Subject: NH 11-1(84)50
Livingston-South
CN 8790000
Geotechnical Engineering Alignment Report (Activity 464) **SUPPLEMENTAL**

Please replace Section 3.2.2 of the March 8, 2018 Geotechnical Engineering Alignment Report (Activity 464) with the following:

Figure 7a. Special Borrow Placement for Subgrade Support. Station 45+00 to Station 53+00.

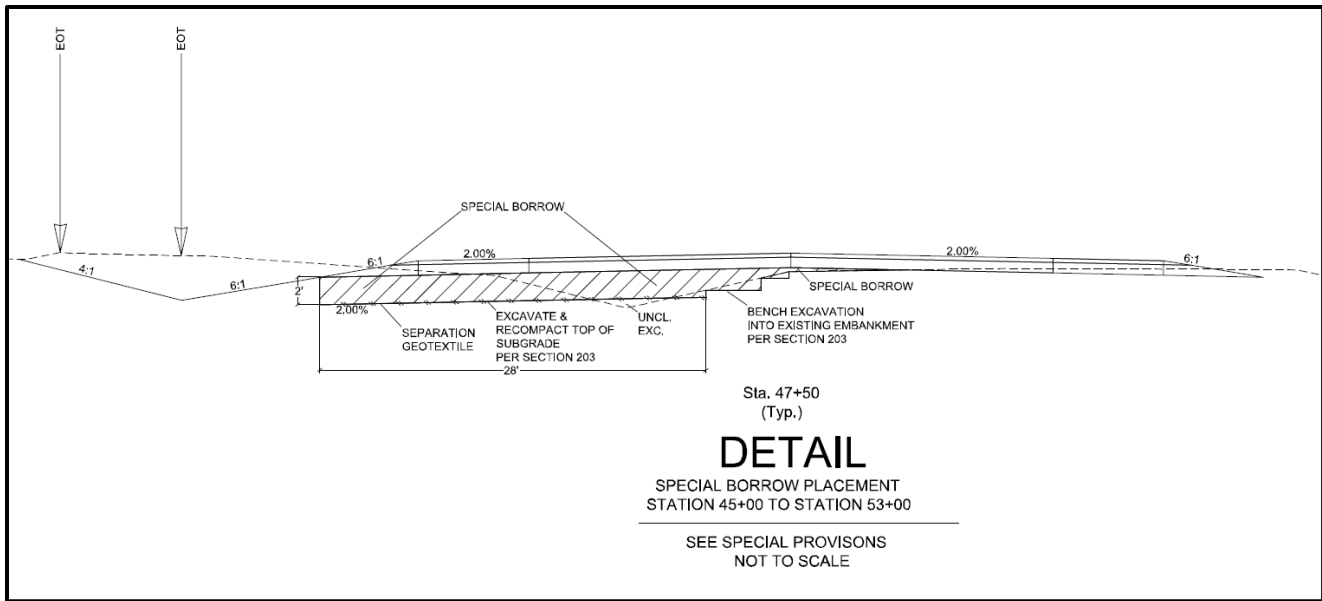
To mitigate for the presence of near surface very loose silty sand and provide the required subgrade structural support, we recommend that between Station 45+00 and Station 53+00 the top 2 feet of subgrade below the typical section (measured at the left edge of the surfacing section) consist of properly compacted special borrow in accordance with Section 203. Prior to placement of special borrow, the top 8 inches of subgrade will be recompacted in accordance with Section 203 and separation geotextile will be placed at the bottom of the excavation. The excavation will match the surfacing grade for 28 feet and then bench into the existing embankment toe. A special provision for special borrow has been uploaded to DMS and a sketch of the special borrow placement at Station 47+50 is shown in Figure 7a below to assist in preparing details for the final plans.

Figure 7b. Special Borrow Placement for Liquefaction. Station 53+00 to Station 64+50.

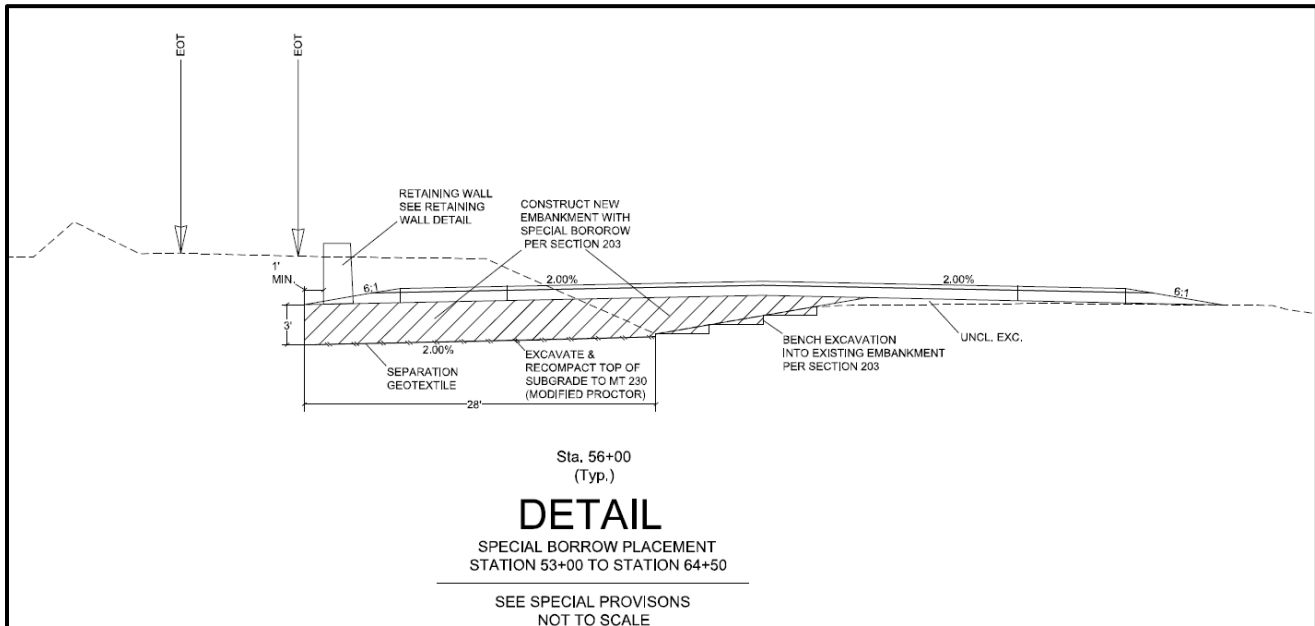
To mitigate some of the anticipated settlement, we recommend that between Station 53+00 and Station 64+50 the top 3 feet of subgrade below the typical section (measured at the left edge of the surfacing section) be excavated, the top 8 inches of subgrade be recompacted to MT 230 (modified proctor) in accordance with the special provisions and separation geotextile be placed at the bottom of the

excavation. Higher compaction effort in this segment of the alignment is recommended to provide increased density to the underlying very loose sand and help reduce liquefaction potential.

New embankments in this segment of the alignment should be constructed with special borrow in accordance with Section 203. The excavation will match the surfacing grade for 28 feet and then bench into the existing embankment toe. Special provisions for compaction of subgrade and placement of special borrow have been uploaded to DMS and a sketch of the excavation and geotextile placement at Station 56+00 is shown in Figure 7b below to assist in preparing details for the final plans.
